RESPONSE TO REQUEST FOR ADDITIONAL INFORMATION

APR1400 Design Certification

Docket No. 52-046

RAI No.: 101-8007
SRP Section: 09.05.05 – Emergency Diesel Engine Cooling Water System
Application Section: 09.05.05
Date of RAI Issue: 07/22/2015

Figure 9.5.5-1 Emergency Diesel Engine Cooling Water System Flow Diagram (Sheet 1 of 1)

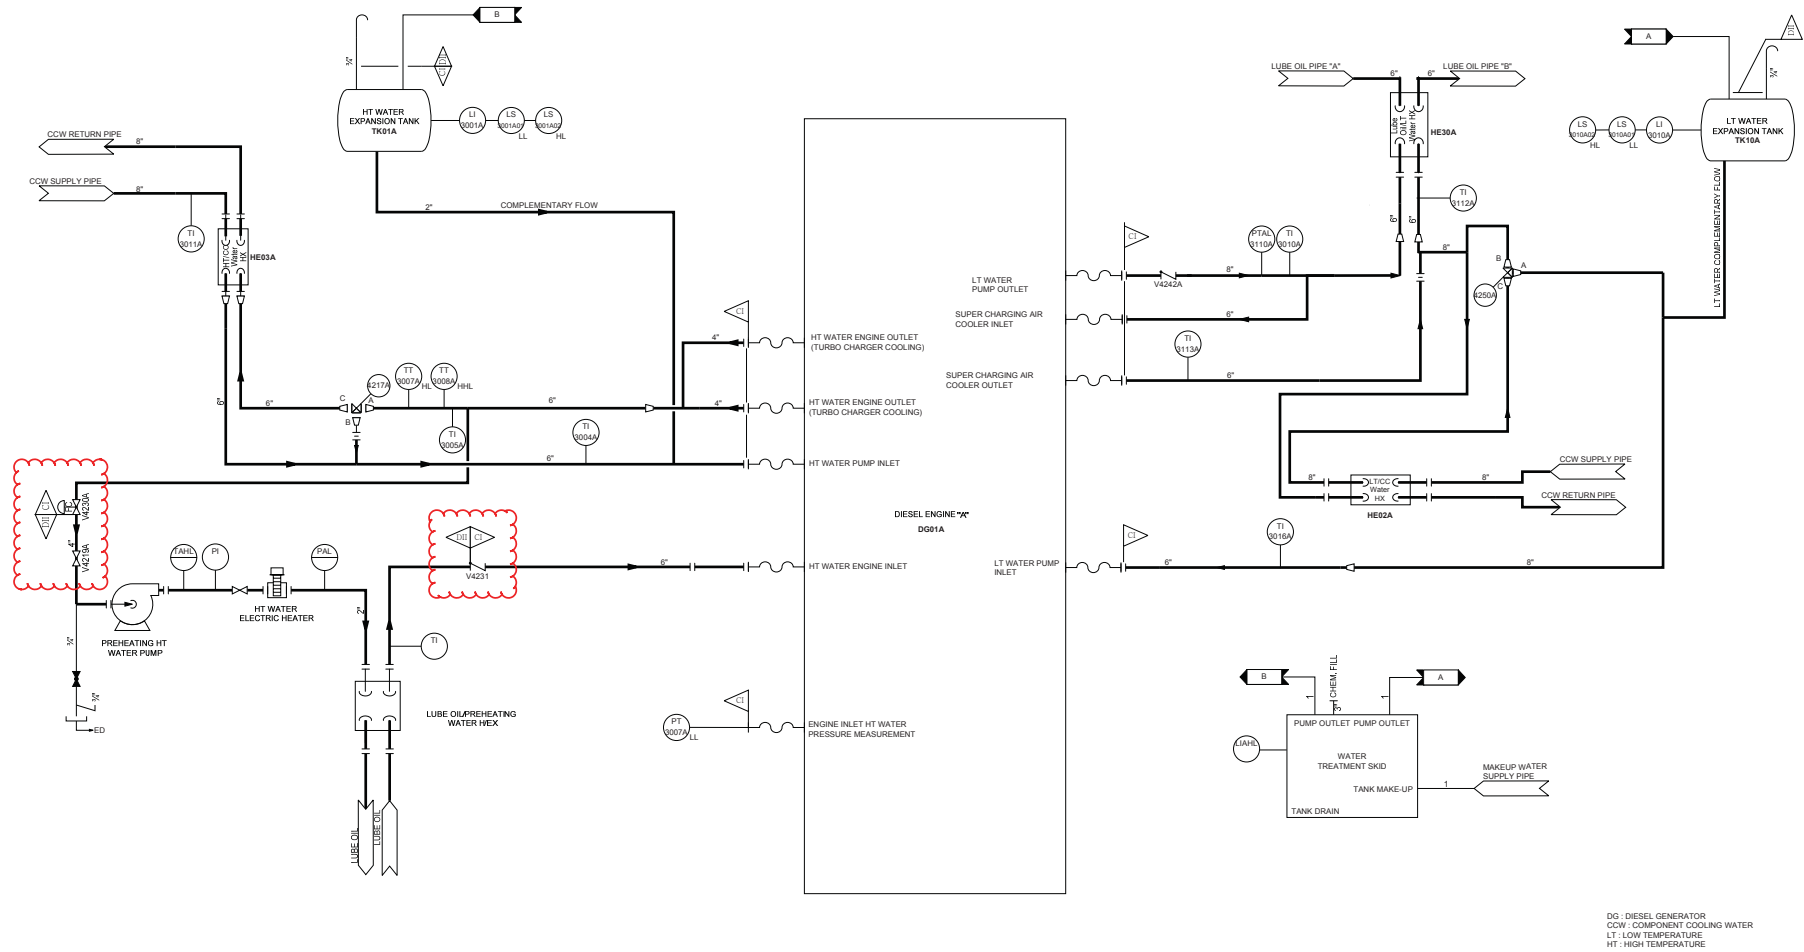
DCD Tier 2, Figure 9.5.5-1 contains the interface between the nonsafety-related pre-heat water system and the safety-related portions of the high temperature (HT) cooling water system. The figure shows an isolation valve classified as seismic category II and quality group D.

The applicant is requested to justify how this classification is sufficient to protect a safety-related, seismic category I system, in the event of failure of a nonsafety-related SSC.

The isolation valve is designed and classified as seismic Category I and quality group C.

DCD Tier 1, Table 2.6.2-2 and Tier 2, Figure 9.5.5-1 and Tables 3.9-4, 3.9-13, and 3.11-3 will be revised as indicated on the attached markup.
